SUNDRY NOTICES AND REPORTS ON WELLS (DO NOT USE THIS FORM FOR PROPOSALS TO DRILL OR TO DEEPEN OR PLUG BACK TO A DIFFERENT RESERVOIR. USE "APPLICATION FOR PERMIT" (FORM C-101) FOR SUCH PROPOSALS.) 1. Type of Well: Oil Well <input type="checkbox"/> Gas Well <input type="checkbox"/> Other INJECTION		WELL API NO. 30-025-06466

PROPOSED PROCEDURE TO REPAIR

NORTHEAST DRINKARD UNIT #525 (30-025-06466)

Operator: APACHE CORPORATION 303 Veterans Airpark Ln Midland, TX 79705	OGRID: 873
	Action Number: 501053
	Action Type: [C-103] NOI Workover (C-103G)

Current/Proposed Schematic

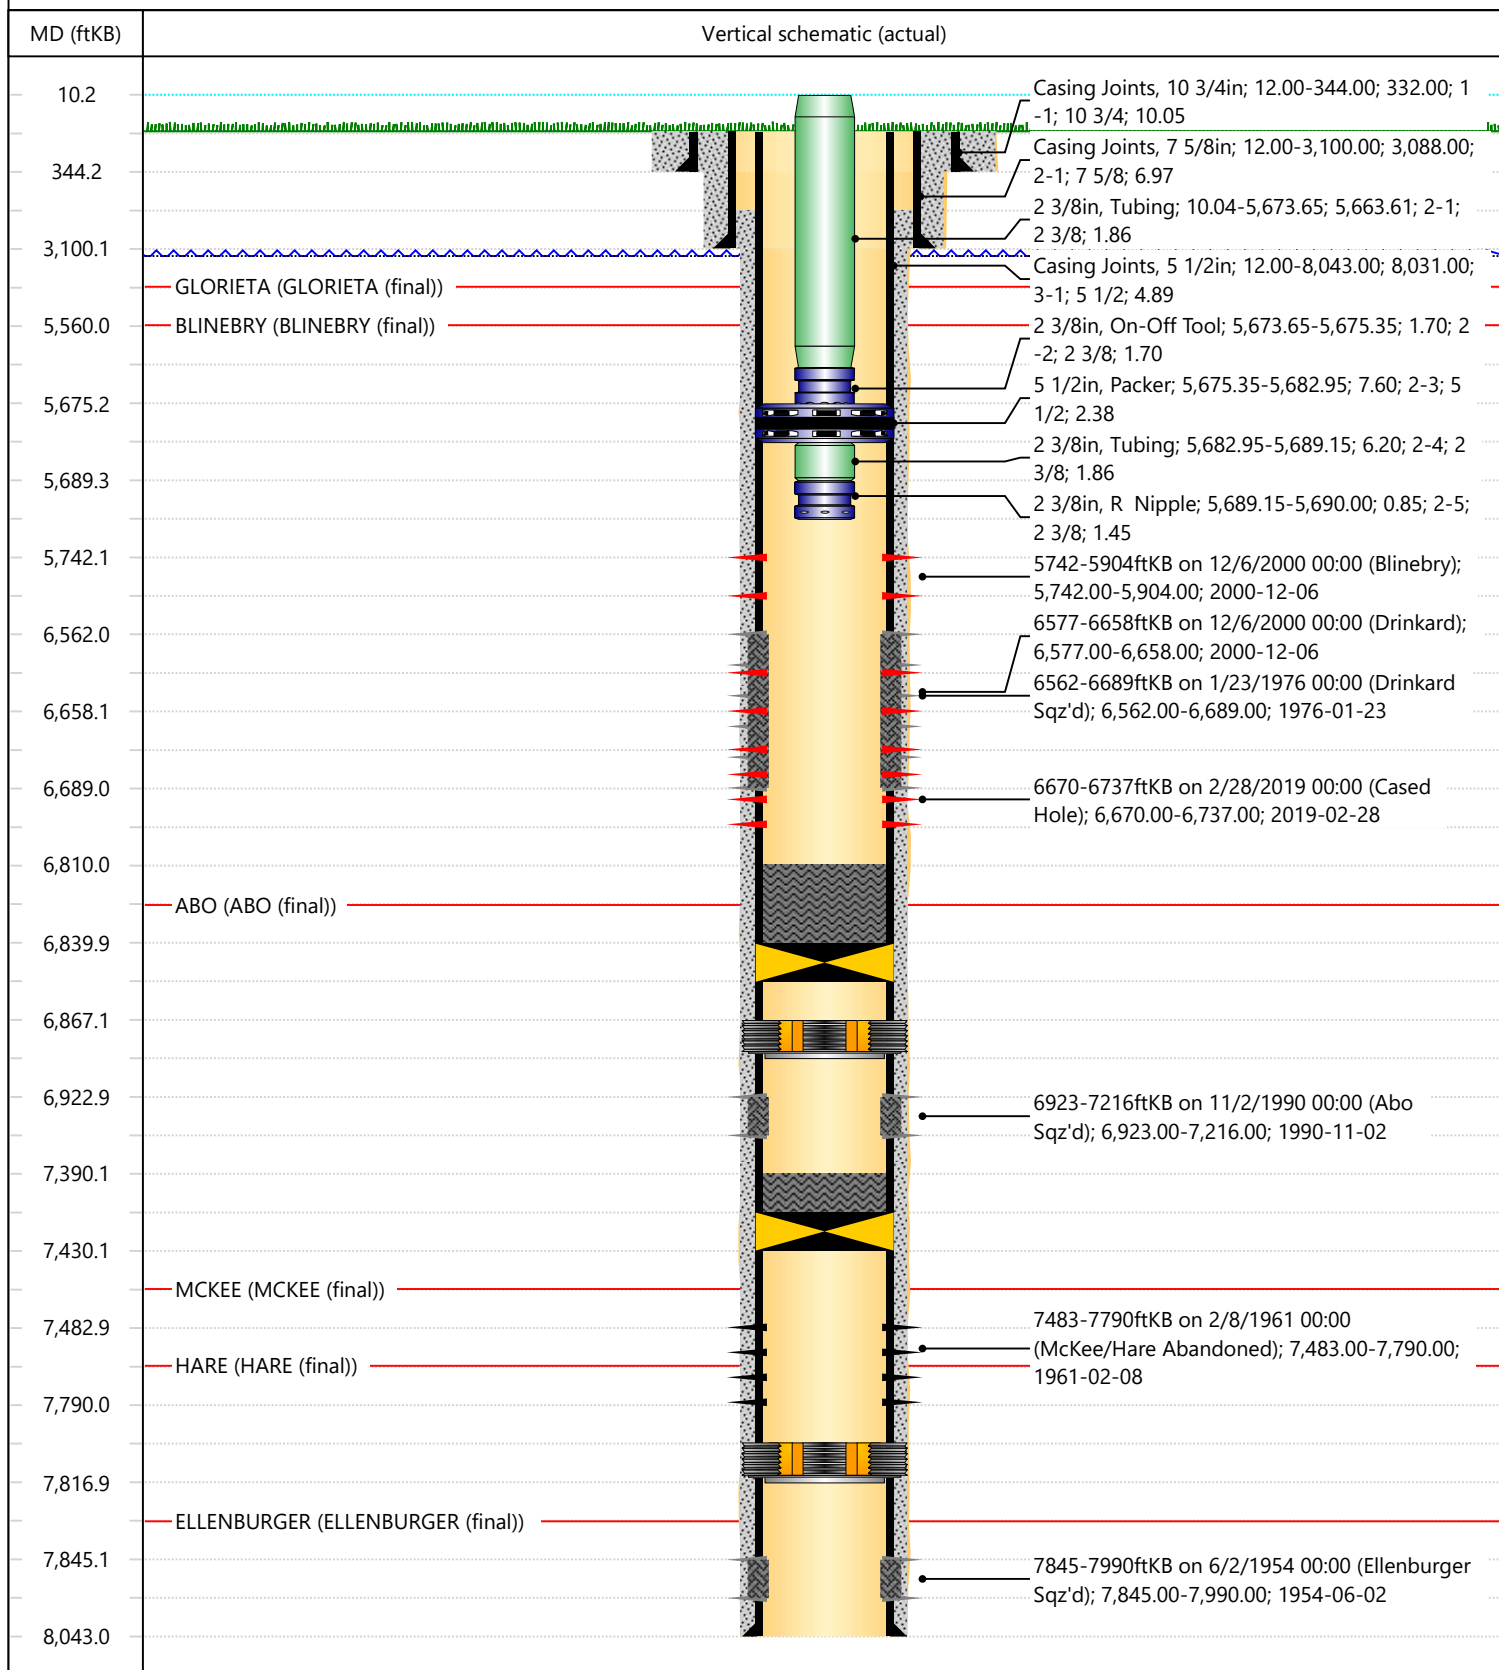
Created By	Condition	Condition Date
anthony.harris	Post workover MIT required with OCD witness	2/24/2026
anthony.harris	No tubing upsize permitted	2/24/2026
anthony.harris	If completion components are altered from those depicted in the Wellbore diagram attached to this NOI, please submit a post-workover C-103 Subsequent report summarizing the work completed and attach an updated wellbore diagram.	2/24/2026
